Subject: Limerick Generating Station, Units 1 & 2
Request for Additional Information (RAI)
from NRC Instrumentation and Control
Systems Branch

Reference: Letter, A. Schwencer to E. G. Bauer, Jr.
dated August 25, 1982

Transmitted herewith are draft responses and FSAR page changes related to the subject RAIs. This material is provided in draft form at the request of Mr. Virgilio, NRC staff reviewer, in advance of a meeting the week of March 14, 1983. We plan to formally incorporate these responses and page changes into the FSAR subsequent to the March 14 meeting.

LIMERICK GENERATING STATION UNITS 1 AND 2 FINAL SAFETY ANALYSIS REPORT
AUTOMATIC INITIATION LOGIC-HPCI
FIGURE 7.3-5

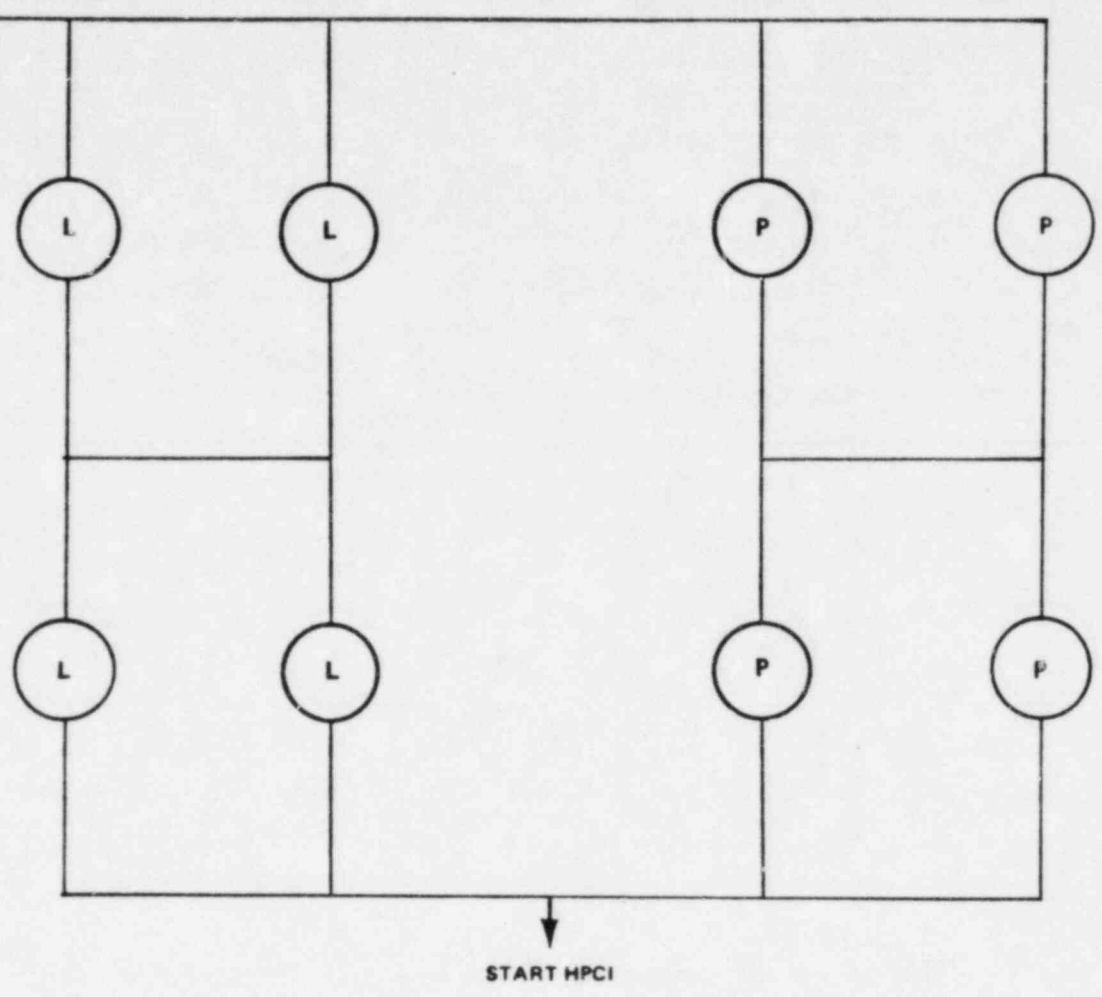
There appears to be a discrepancy between the number of instrumentation channels as described in Section 7.3.1.1.1.1.3 and the logic shown in Figure 7.3-7. Also the logic shown in Figure 7.3-5 does not agree with the logic in Figure 7.3-7 or the logic described in Section 7.3.1.1.1.1.4. Describe the as-built system and correct apparent discrepancies.

Figure 7.3-5 and Section 7.3.1.1.1.1.3 have been changed to correct the discrepancies. A revised Figure 7.3-7 will be provided by June 1983. There are four level transmitters and four drywell pressure transmitters incorporated in the HPCI initiation circuitry. The four trip units that operate off the level transmitters are combined in a one-out-of-two-twice logic for automatic system initiation. The same is true for the drywell pressure transmitter/trip units. Either of the two logic trains will initiate the system. The turbine trip logic for high water level is also one-out-of-two-twice and not two-out-of-two as stated in the text. Section 7.3.1.1.1.4 is correct in its description of the initiation logics.

FIGURE 7.3.4

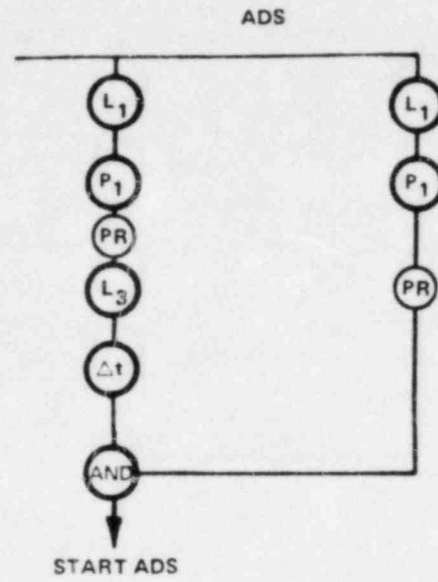
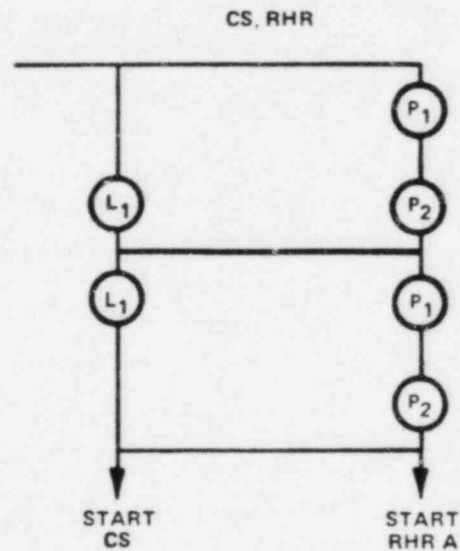
The description of the initiation logic for the ADS includes a permissive interlock from the LPCI or the CS pumps running signal. This permissive, however, is not shown on Figure 7.3-4. Correct the apparent discrepancy.

Figure 7.3-4 has been revised to agree with the description of the initiation logic for the ADS.
